MWO 9-2320-280-20-4

MODIFICATION WORK ORDER

**MODIFICATION OF 1-1/4 TON VEHICLES
M998 SERIES
STEERING COLUMN INSPECTION AND BRACKET INSTALLATION**

Headquarters, Department of the Army, Washington, D.C.
15 April 1996

FIGURE 1

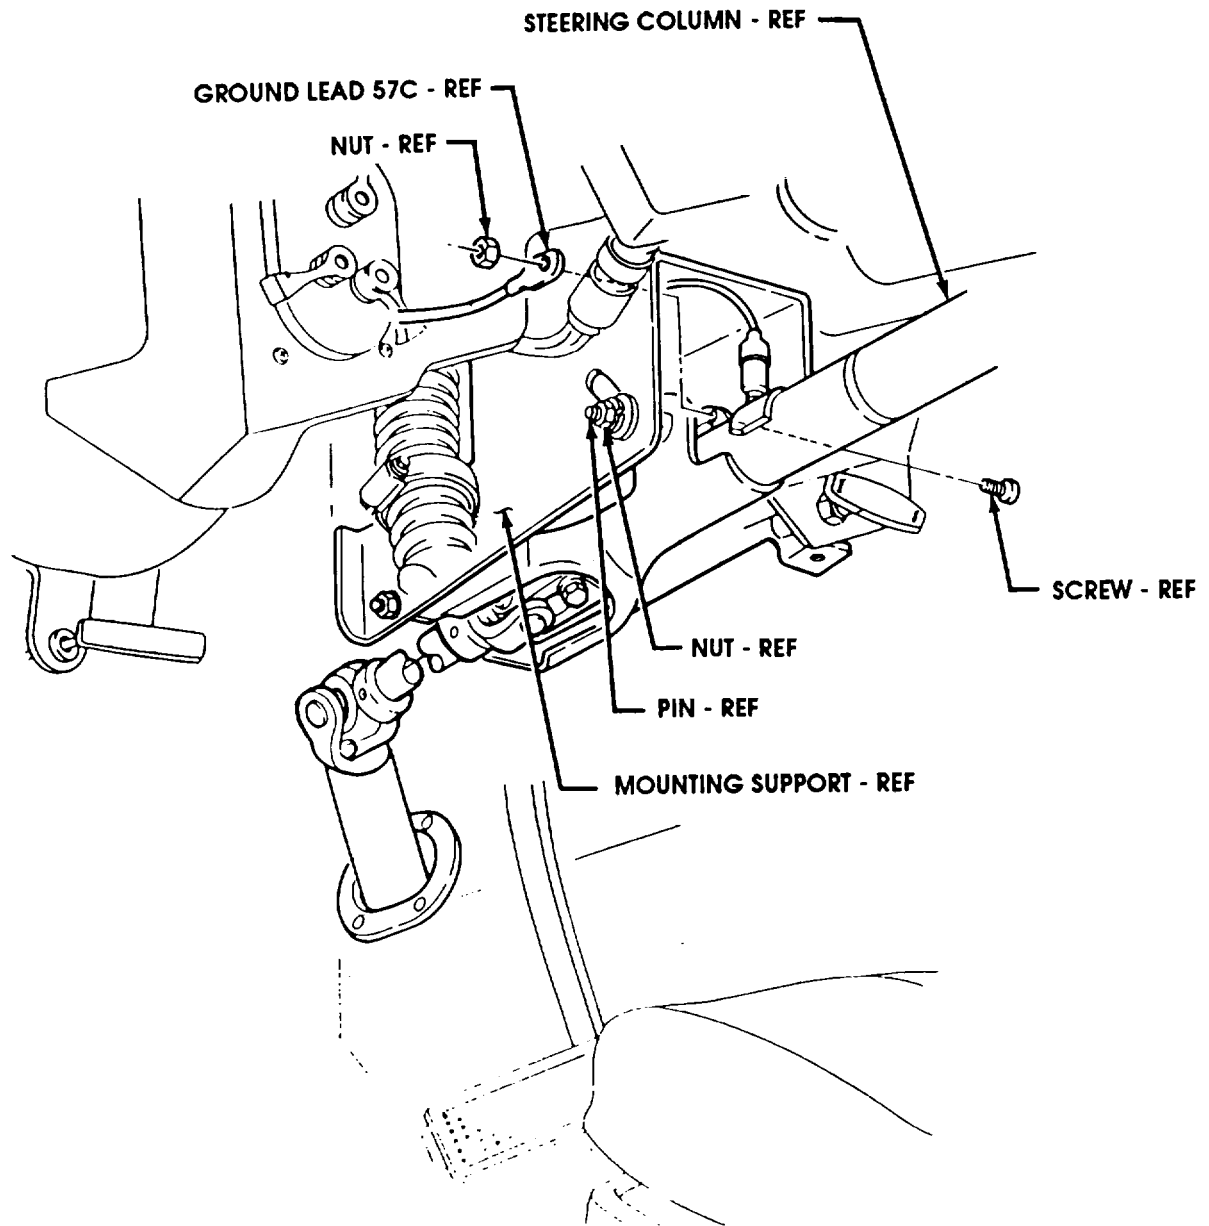
- (1) Loosen nut on pin and place steering column in down position on mounting support as shown in figure 1.

- (1) Remove screw, nut, and ground lead 57C from steering column as shown in figure 1.
- (2) Secure ground lead 57C and 12342875 bracket to steering column with 431942 screw and 271169 nut as shown in figure 3. Do not tighten nut.
- (3) Secure 12342876 bracket to bracket (12342875) and steering column with B1821BH025C1OON screw, two MS27183-10 washers, and MS51943-31 nut as shown in figure 3. Tighten nut to 10 lb-ft (14 N•m).
- (4) Tighten nut (271169) installed in step "2" as shown in figure 3.
- (5) Place steering column and pin in upward position on mounting support until steering column cannot be raised any further as shown in figure 5. Tighten nut on pin to 14 lb-ft (19 N•m).

FIGURE 2

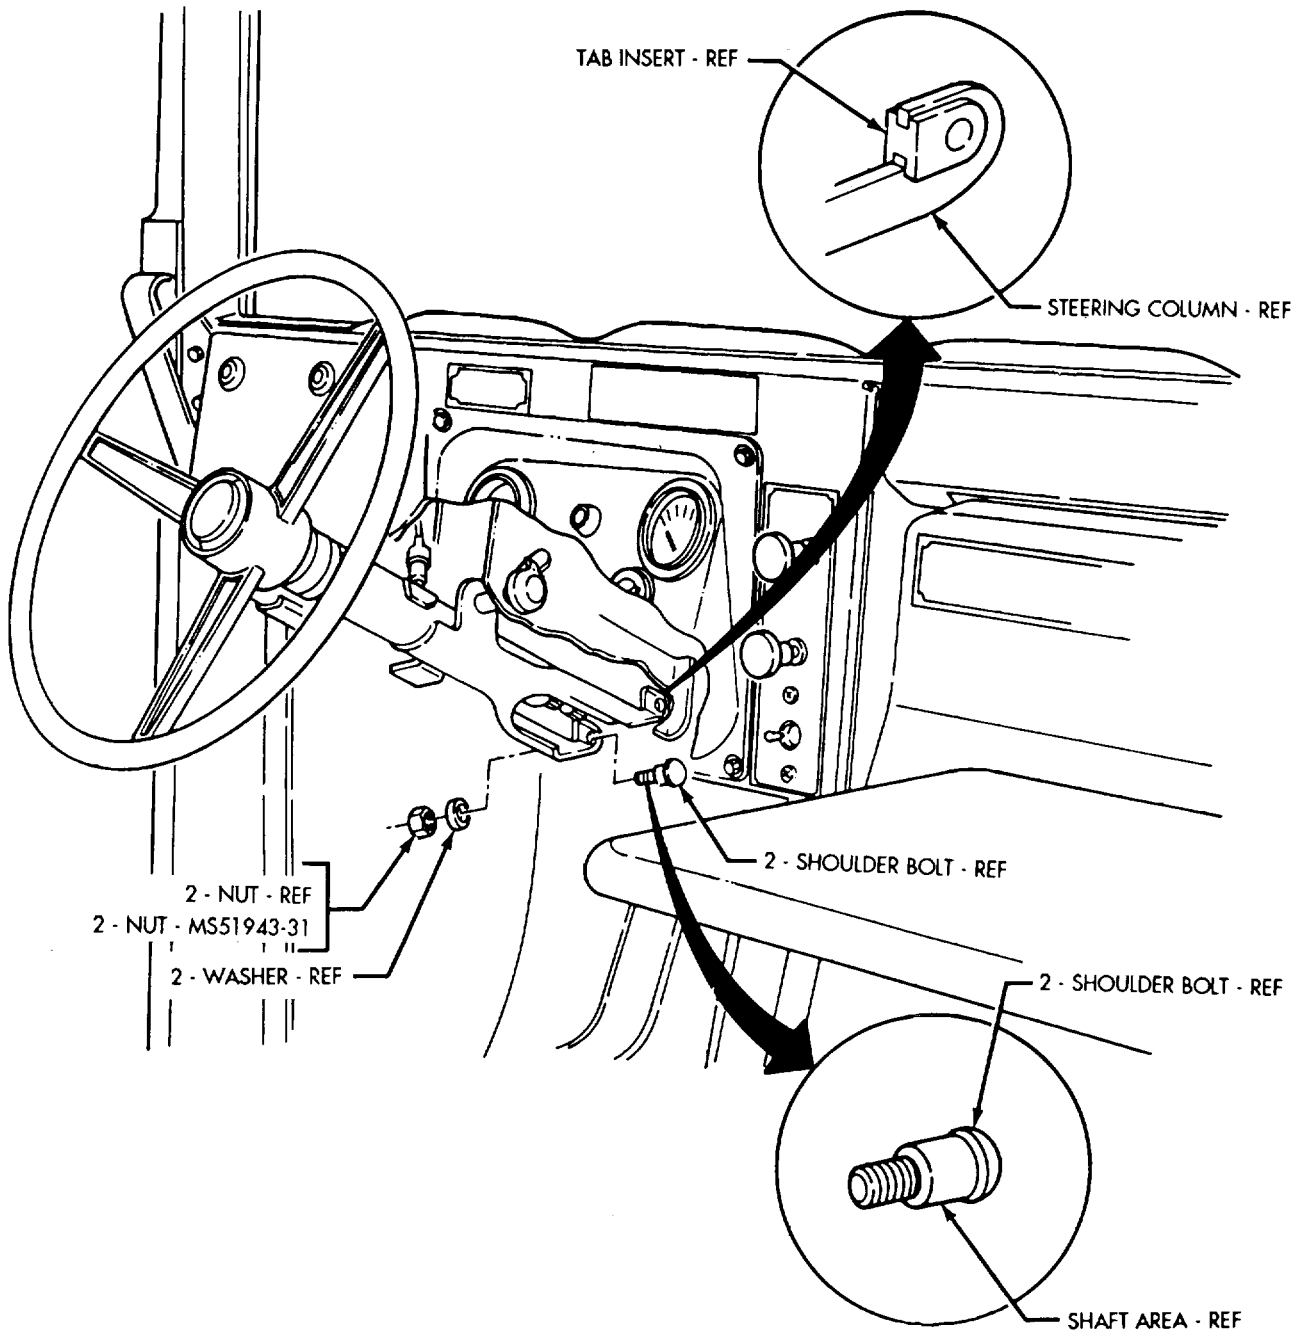
- (2) Remove two shoulder bolts, washers, and nuts from steering column as shown in figure 2.
- (3) Check tab inserts at end of steering column for paint and metal cracking as shown in figure 2. If cracking is present on or around tab inserts, discontinue inspection procedure and replace steering column (Refer to TM 9-2320-280-20).

- **Check shoulder bolts removed in step "2" for "mushrooming" around shaft area of shoulder bolt as shown in figure 2. If mushrooming is present, replace shoulder bolts, washers, and nuts (Refer to TM 9-2320280-20).**
- **If mushrooming is not present, perform step "4".**

- (4) Install two existing shoulder bolts, washers, and two MS51943-31 nuts as shown in figure 2. Tighten nuts to 10 lb-ft (14 N-m).

FIGURE 4

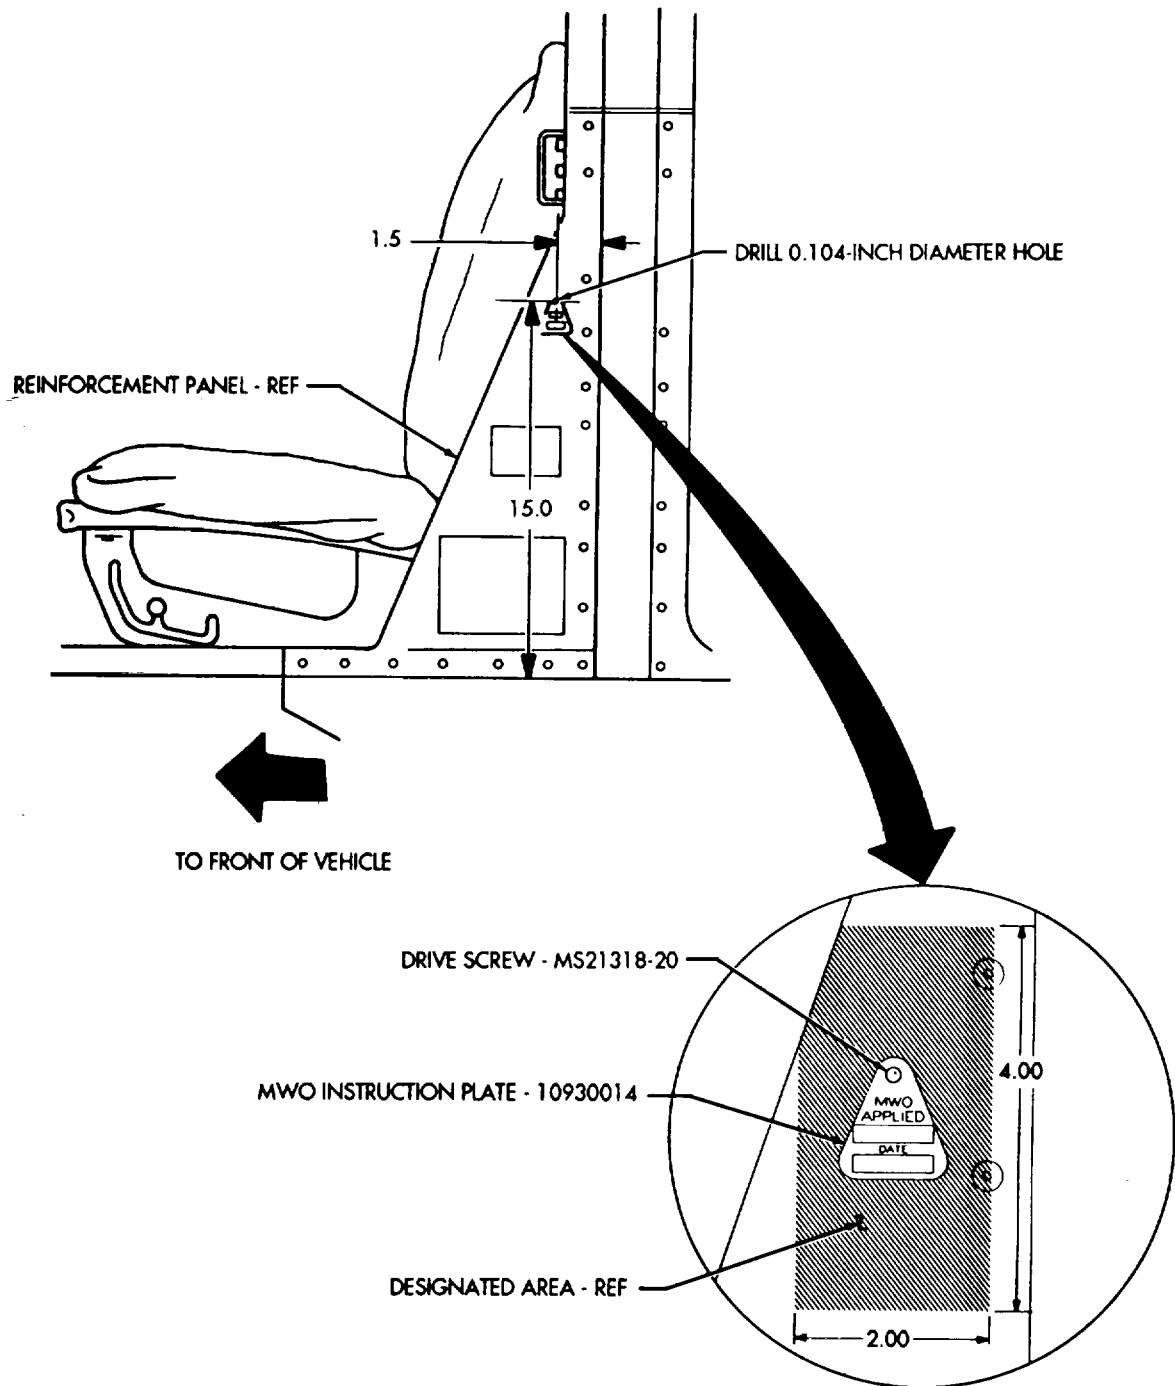
(2) Install 10930014 MWO instruction plate by drilling a 0.104-inch diameter hole within designated area on body reinforcement panel and secure with MS21318-20 drive screw as shown in figure 4.

FIGURE 5

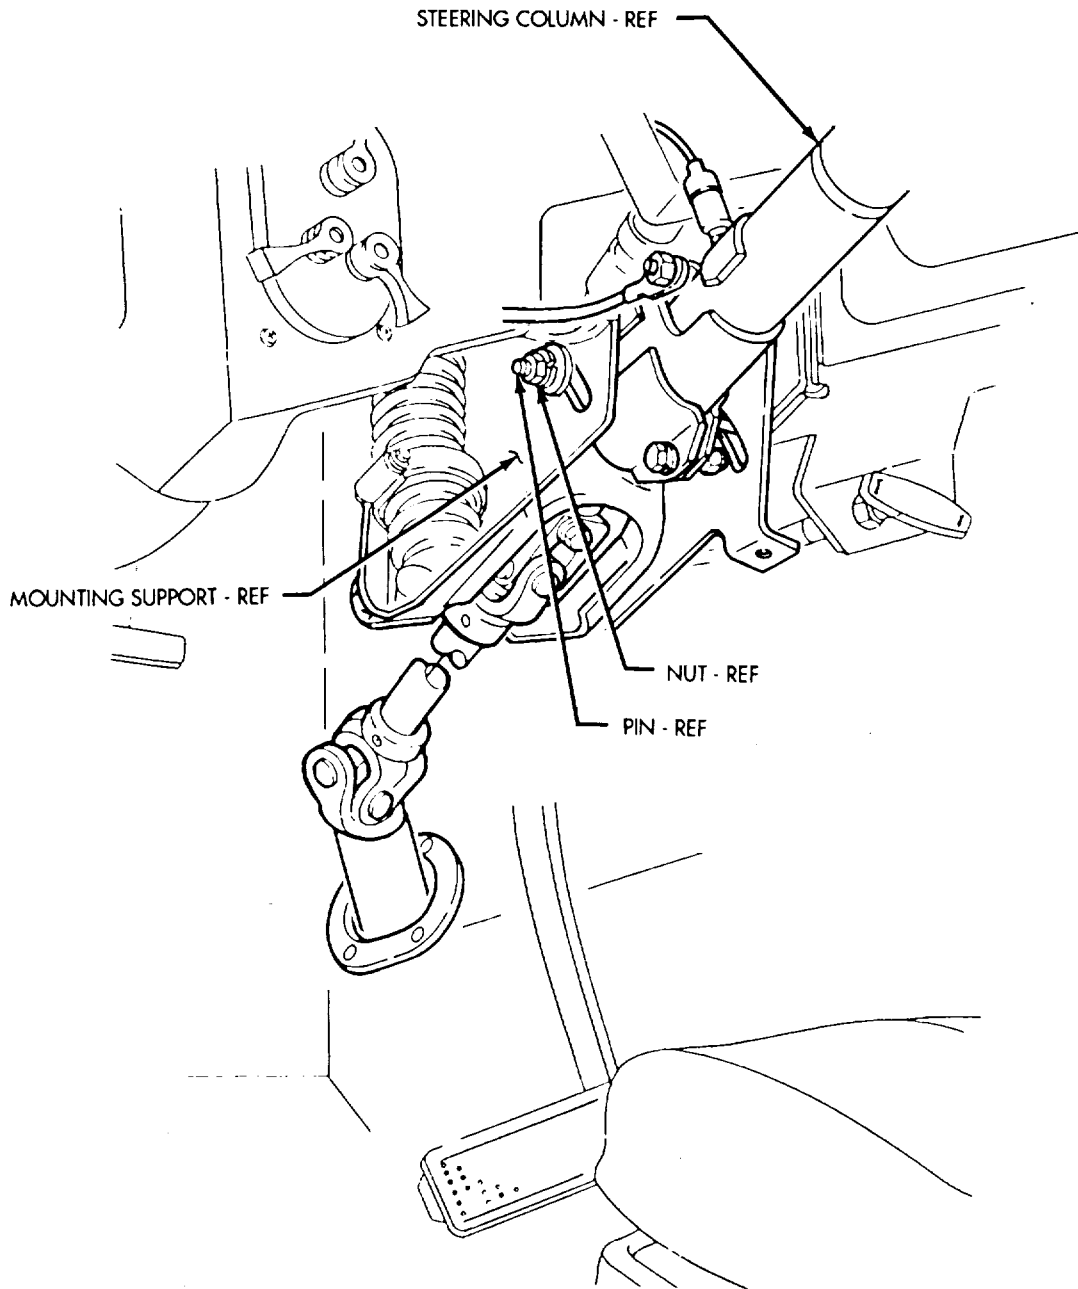
a. When installed correctly, the steering column brackets will appear as shown in figure 5.
